SUBJECT: MEETING SUMMARY - MEETING WITH STP NUCLEAR OPERATING COMPANY TO DISCUSS THE PROPOSED 3-VOLT ALTERNATE REPAIR CRITERIA FOR SOUTH TEXAS PROJECT, UNIT 2, STEAM GENERATORS (TAC NO. MA8271)

South Texas Unit 2 – 3 Volt ARC

Technical Discussion on NRC RAI

Figure 3-1. Schematic of Model E Steam Generator

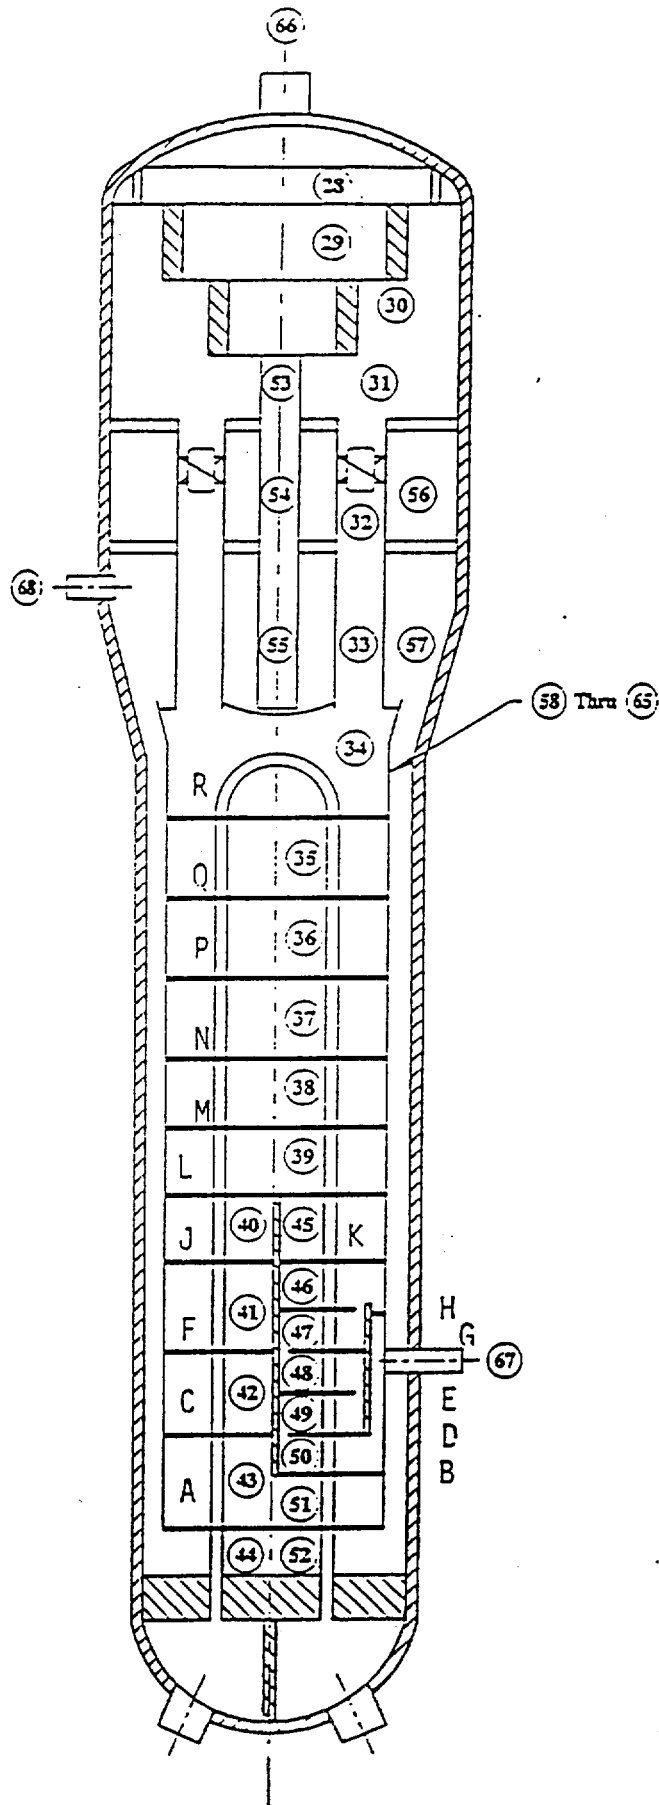
Please justify the applicability of the referenced test facility to determination of TSP loss coefficients. Also address the adequacy of your Figure 4-4 comparison of a correlation with data when the loss coefficient of interest appears to be outside the range of the data.

How does RELAP-5 provide tube and TSP loadings and vibration in the axial cross-tube flow pattern areas of the preheater and flow distribution baffle (FDB) regions? Please address, for example, the non-uniformity of the loading under cross-flow conditions and how this is addressed in your analysis.

Geometry of Steam Generator

- Flow Restrictor in Nozzle
- Upper Steam Separators
- Swirl Vane Separators
- Deck Plate
- Wrapper Forming Downcomer
- Tube Support Plates

- Nozzle Restrictor - 1.4 Sq Ft
- Inside Nozzle - 107.7 Sq Ft
- Between Separators - 193.2 Sq Ft
- Tube Bundle Between TSP's - 68.62 Sq Ft
- Through TSP's (Typical) - 19.1 Sq Ft
- Downcomer - 9.8 Sq Ft
- Downcomer Windows - 9.8 Sq Ft

Steam Line Break From Hot Standby

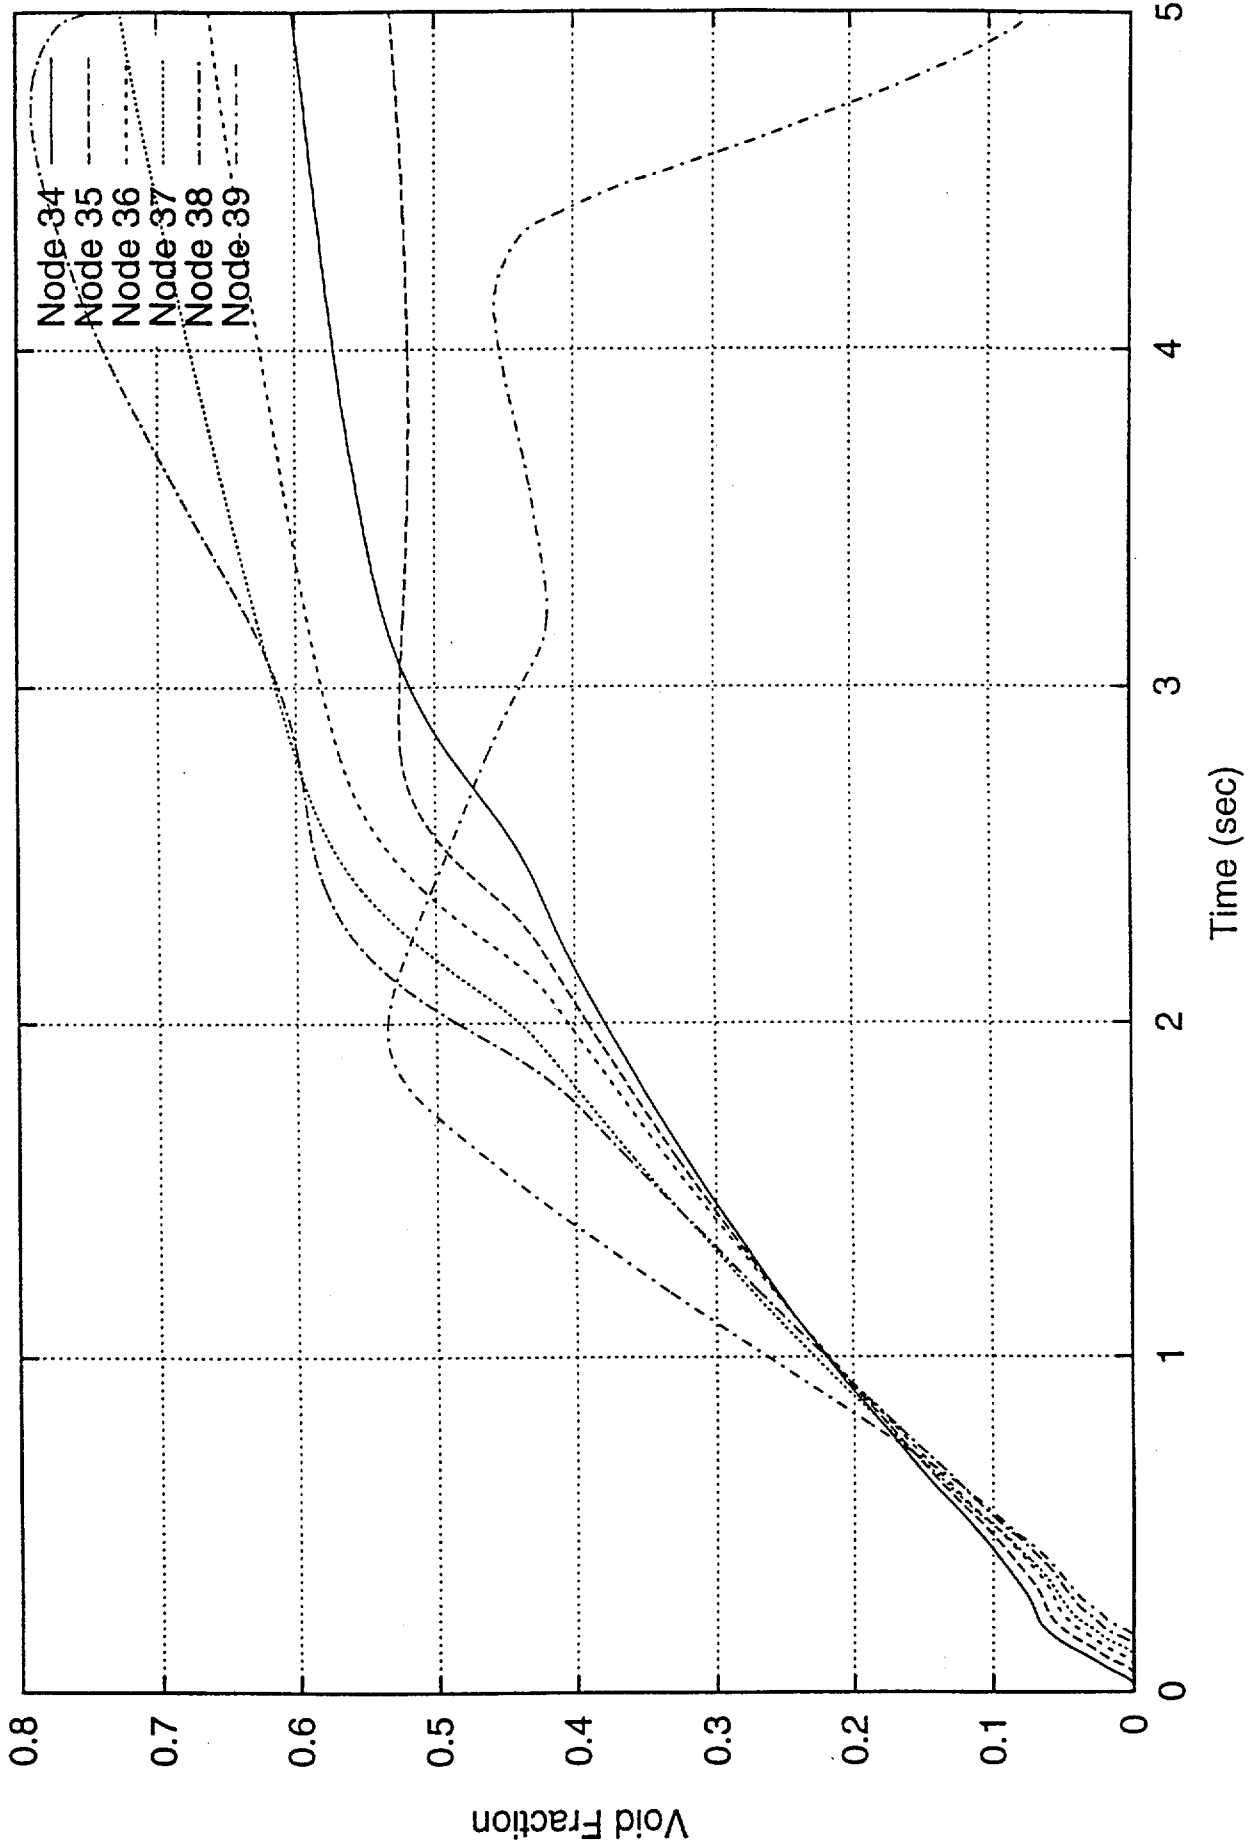
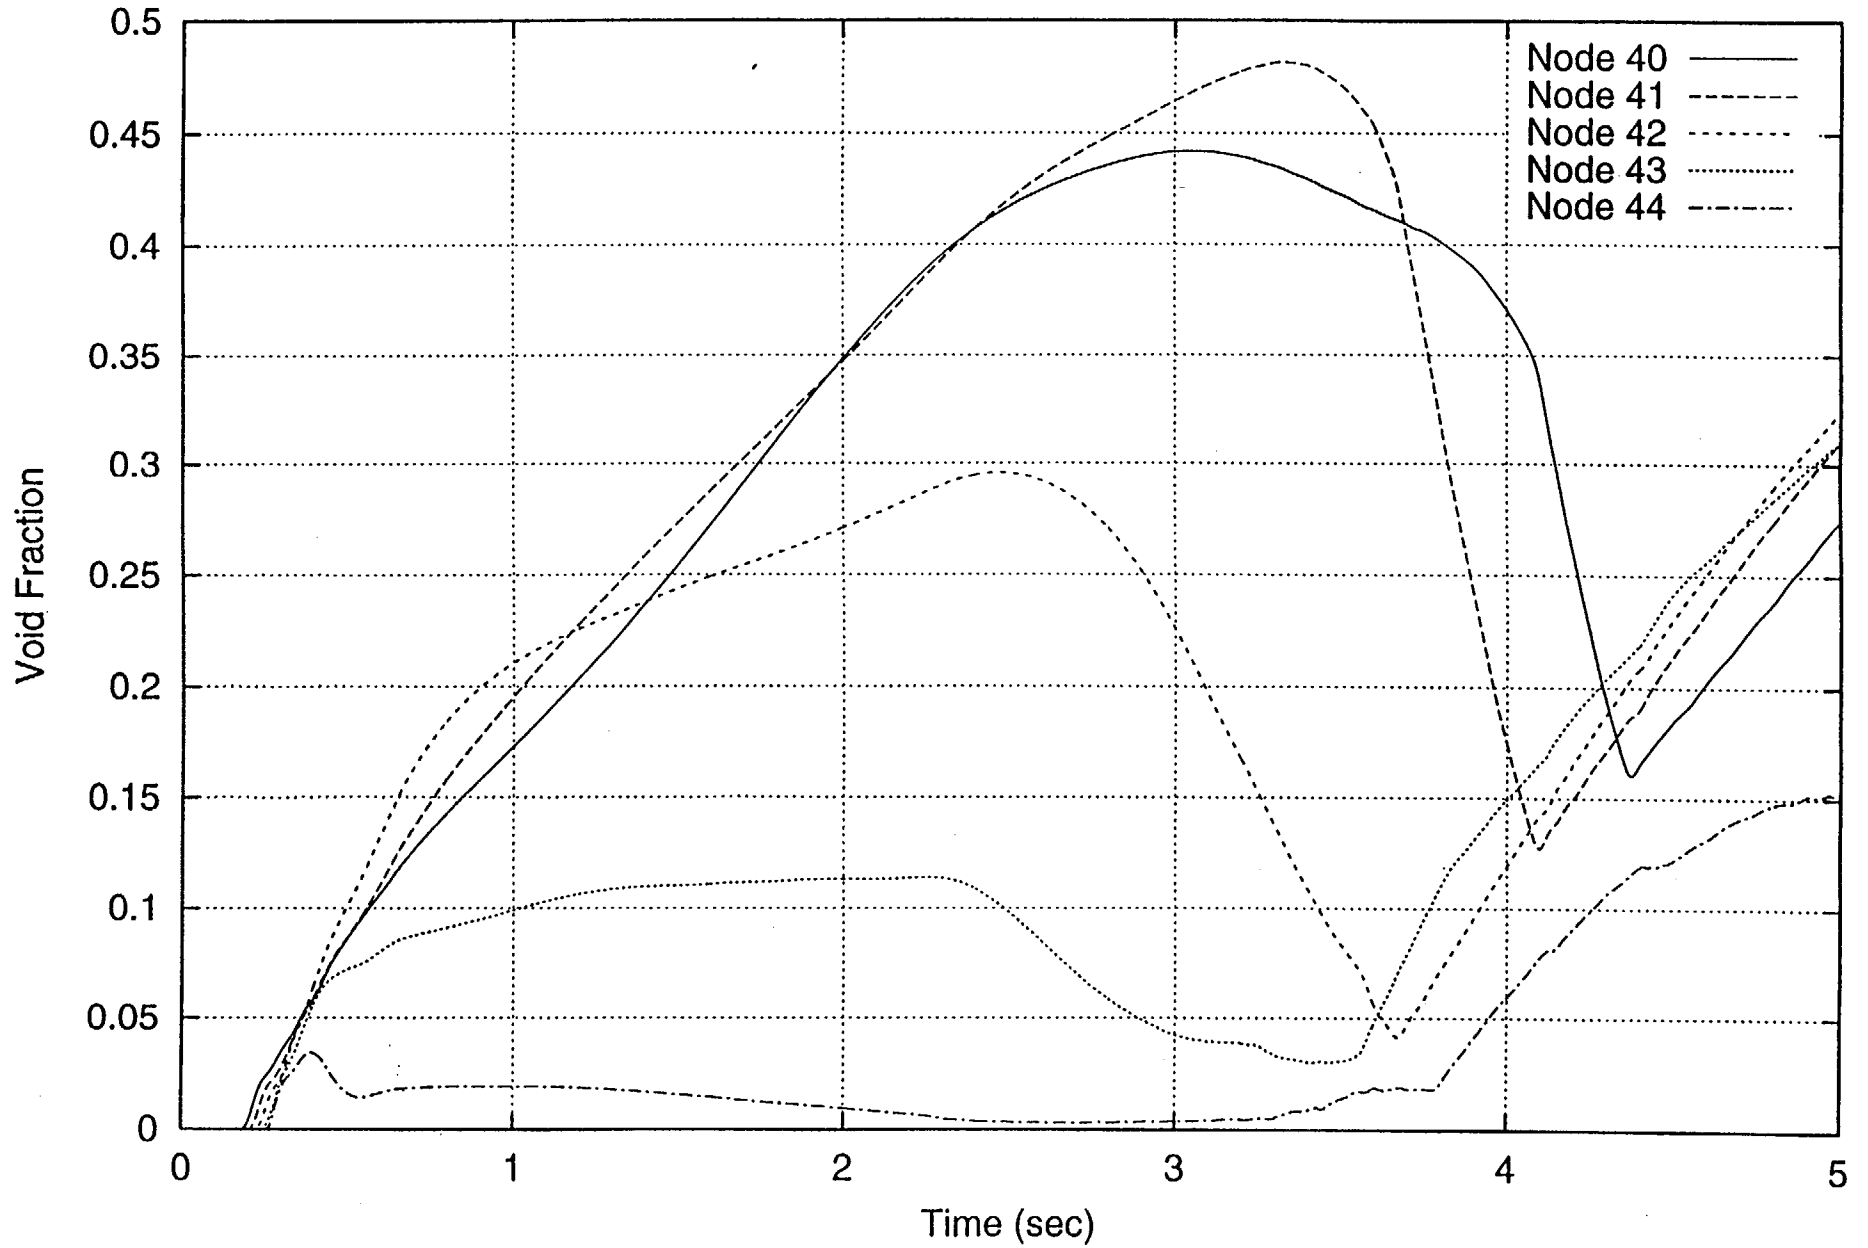
Please address the adequacy of fluid nodding with respect to local void generation and local void/liquid slugs throughout the SG internals. Include propagation/movement through the SG structure, generation of local loads as a result of generation/movement, transition of these loads into mechanical movement, and feedback of this mechanical movement into the fluid behavior. Include a discussion of the applicability of RELAP-5 to analysis of this behavior for normal operation, during upset conditions, and under accident conditions. (Note your sensitivity calculation with radial nodes near the top of the SG may not be sufficient to address the local fluid aspects of this question because (1) RELAP-5 has not been shown to apply and (2) the maximum calculated TSP deflection and maximum cross flow rates do not occur in the region of your sensitivity calculation.)

- **Due to Ratios of Flow Areas, Internal Pressure Drops in Tube Bundle Region are not Large**
- **Dominant TSP Loads are Produced when MSLB occurs from Hot Standby Condition due to “Swell” from Void generation**

- Largest indications occur at lowest TSP where displacements are the smallest (0.05")
- The bounding hydraulic load based on a simplified model is a factor of xxx times the predicted RELAP loads
 - Calculated "swell"
 - Upflow through downcomer is zero
- Demonstrates that RELAP appropriately models SLB transient
- Substantial margin is provided to cover any realistic uncertainties
